Flood Risk Assessment and Drainage Strategy

Proposed Development at
Hither Green Lane, Redditch, B98 9BN

Document Type: Flood Risk Assessment and Drainage Strategy

Appendix 10 – NWWM (LLFA) response

STATUS:
PRELIMINARY

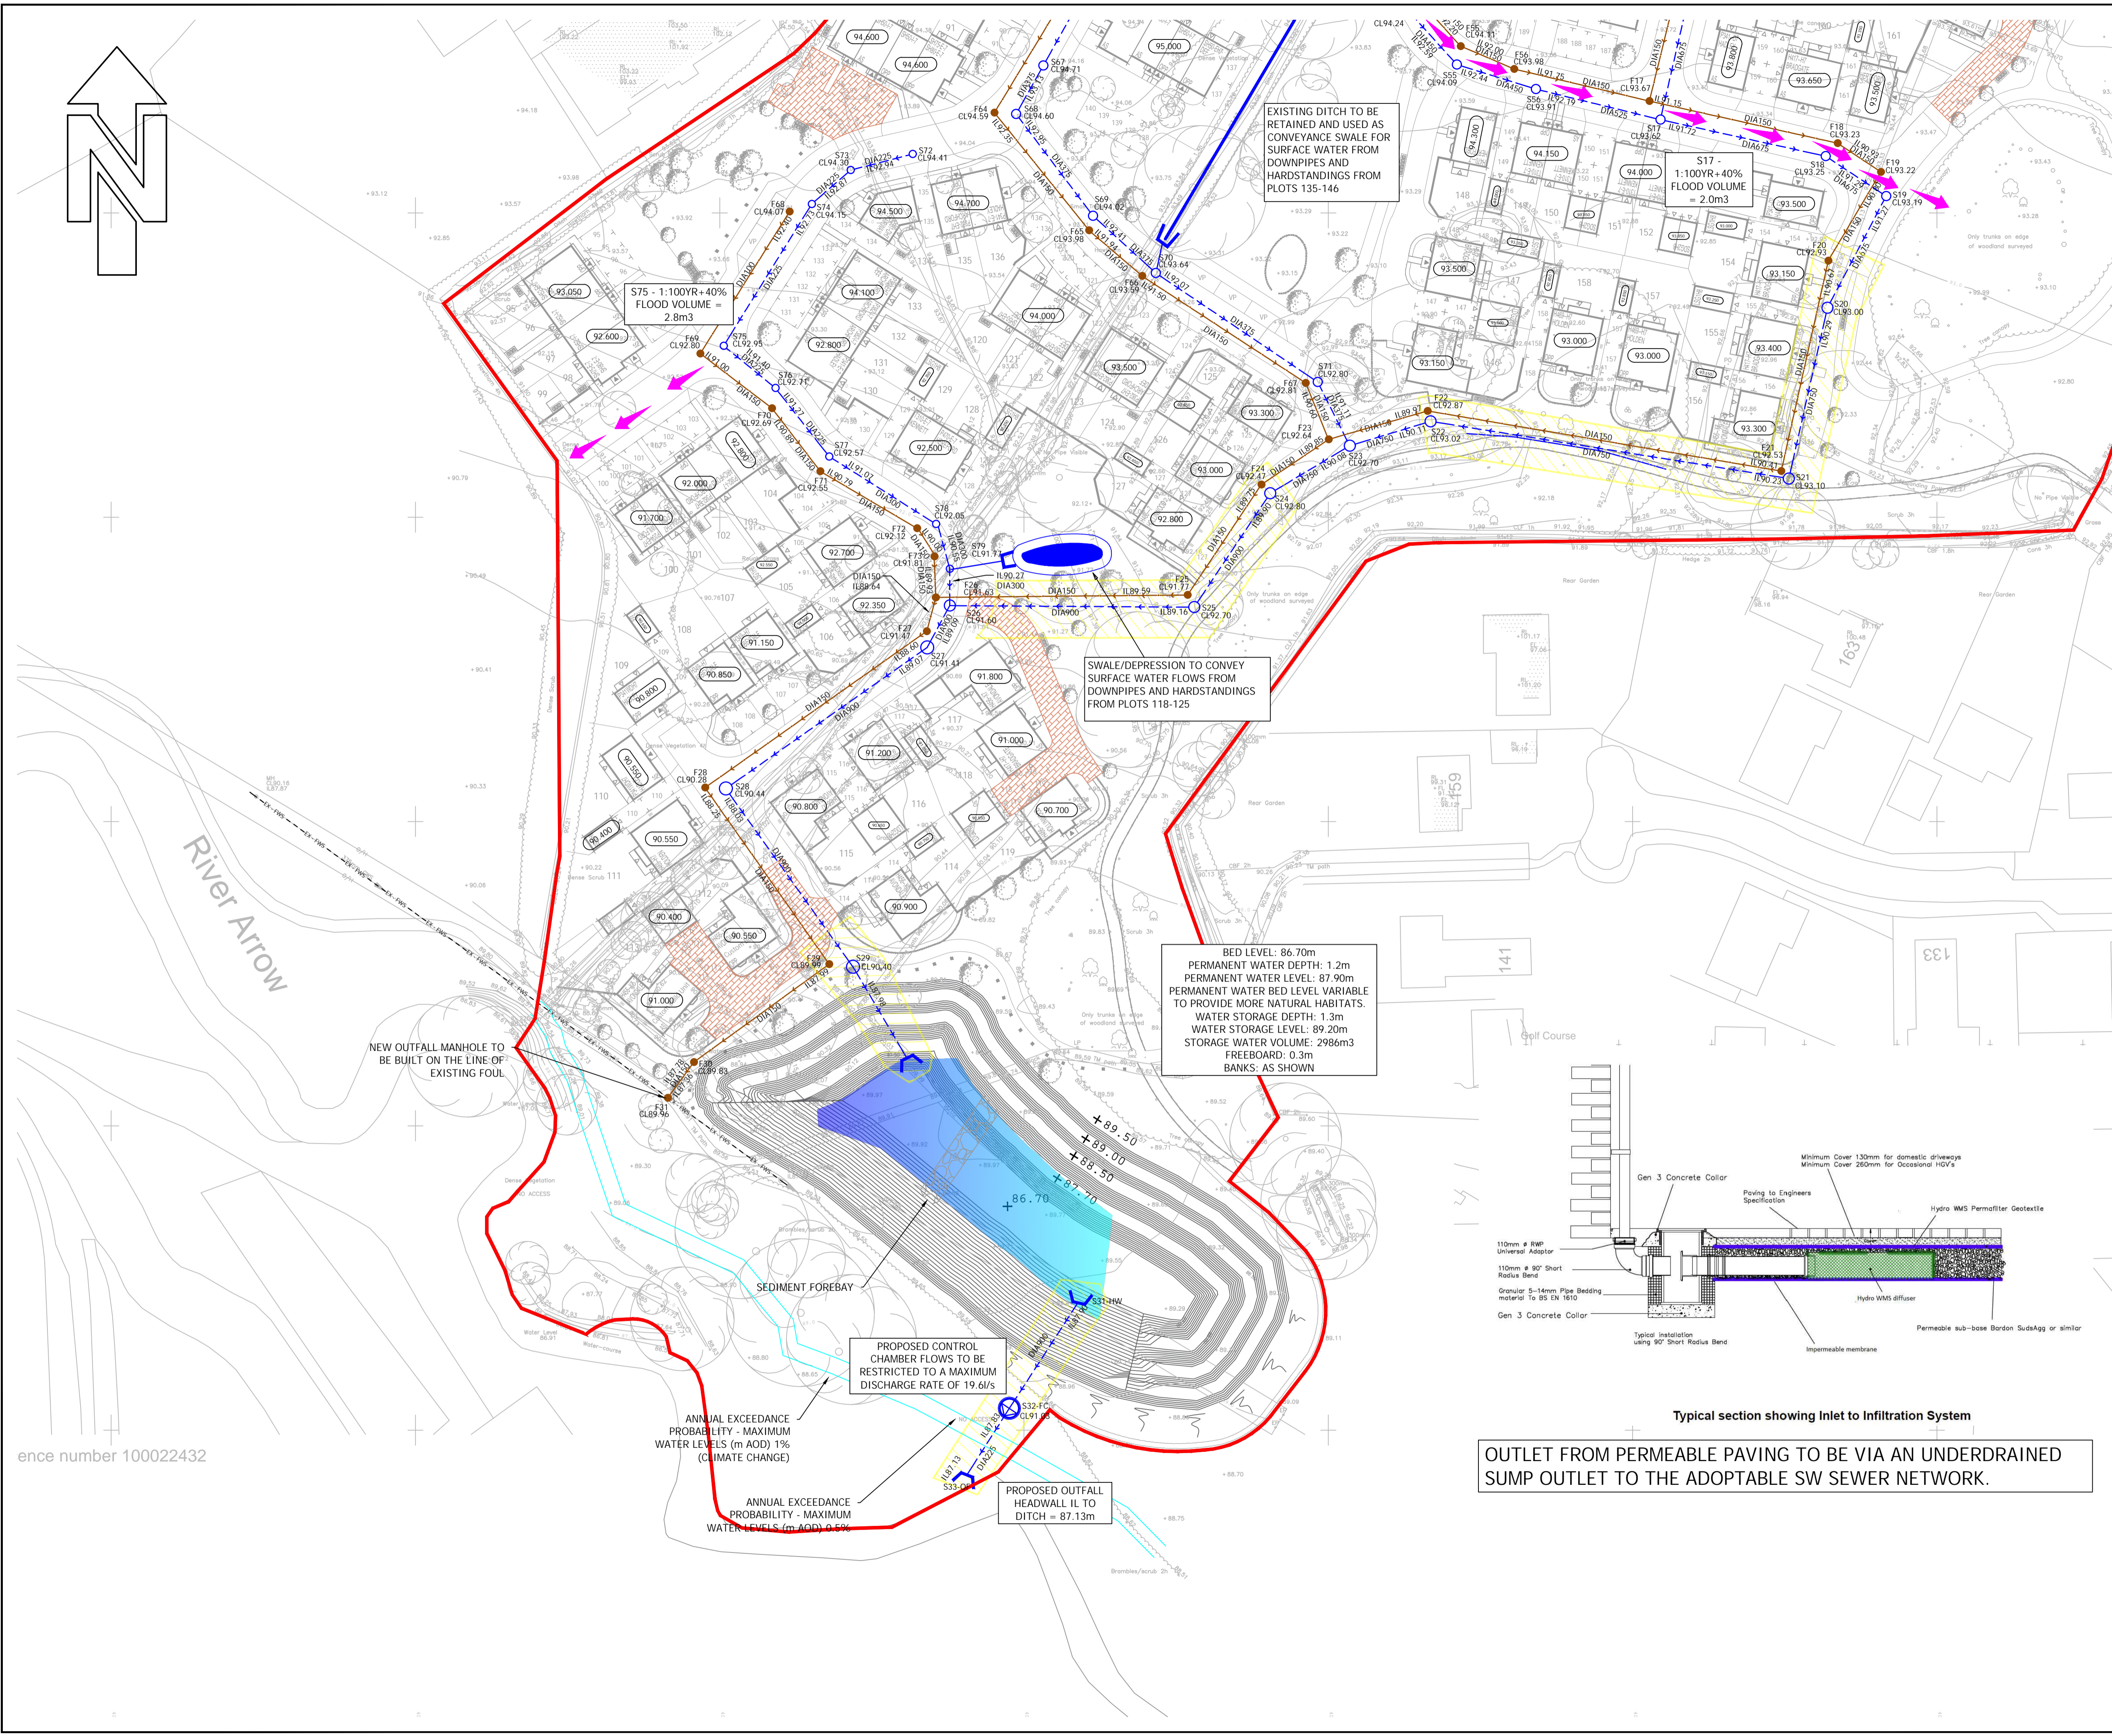
While NWWM is broadly supportive of the principle of development on this site, based on the current proposal for the site there are a several elements that are contrary to policies 17&18 of the Redditch Local Plan. We would raise a **Holding Objection** to this application until the proposed drainage layout is revised and it addresses concerns raised in the following comments.

Within the FRA an outline drainage strategy has been proposed, the proposed level of retention is acceptable (up to 1 in 100 year AEP + 40% for climate change) and the proposed off site discharge rate is acceptable. However, beyond surface water attenuation the proposed drainage scheme provides minimal further benefits. Calculations for the scheme have been provided, however they have not been assessed as they will need to be revised to accommodate revisions to the drainage layout if the scheme to be acceptable to the LLFA.

The use of a single retention feature which is located on the periphery of the development will limit benefits with respect to water quality and amenity. It does include permanent water, which is positive however this it uniformly deep, natural ponds provide a mixture of depth profiles. There are no source control SuDS features provided by the scheme. Features such as permeable paving or drained tree pits should be incorporated into the design.

The site should be split into its natural catchment areas and a series of smaller retention features should be proposed. With the appropriate inclusion of source control features this should ensure there is still suitable attenuation volume provided by the scheme. These features should be incorporated into open space areas so that they provide amenity value. Pedestrian routes can be provided adjacent swales to provide green corridors through the development.

One thing that I did notice hadn't changed the re-route of the pavement with regards to Tom's previous comment...

Can you also confirm if you have incorporated Tom’s comment about permeable paving?...

“With respect to the proposed permeable paving the attached detail is one we have specified on another site recently. The last detail would be how we would want the adjacent properties to have their downpipes connected to the paving, then there would need to be an under drained sump which then connects to the adopted sewer.”

Sorry for being so slow to come back to you on this. I have been trying to speak to the planning officer at Redditch this week but he has been on leave all week and isn't back till Monday. I have reviewed the revised details you sent over. I think given the limitations of severn trent allowing land drainage to their network and the issues of the invasive species we will have to accept the larger pond not being connected to the network. The additional features you have added are welcome, however can you clarify, is the intention that the surface water ,i.e. downpipes from properties will discharge to these features before draining to the sewer network? If so can you just indicate this clearly on the drawing.

With respect to the proposed permeable paving the attached detail is one we have specified an another site recently. The last detail would be how we would want the adjacent properties to have their downpipes connected to the paving, then there would need to be an under drained sump which then connects to the adopted sewer.

I have reviewed the revised drainage strategy and can see that you have rerouted the pavement. Secondly, if you are confirming that you have incorporated the second point from my previous email, I can confirm that I am happy with the latest drainage strategy.

I attach the revised drainage strategy drawings for your approval. Firstly I can confirm that the items below were already incorporated into the scheme. Secondly, following comments from the tree officer we have reduced the number of plots (around plots 136-140) that does not affect the drainage strategy and have moved the inlet and outlets of the southern pond to reduce the effect on surrounding trees. Again this doesn't impact on the drainage strategy itself.

Please find attached revised drainage strategy drawings incorporating the additional features that you requested. I trust they meet with your approval but should you require any further information please do not hesitate to contact me.
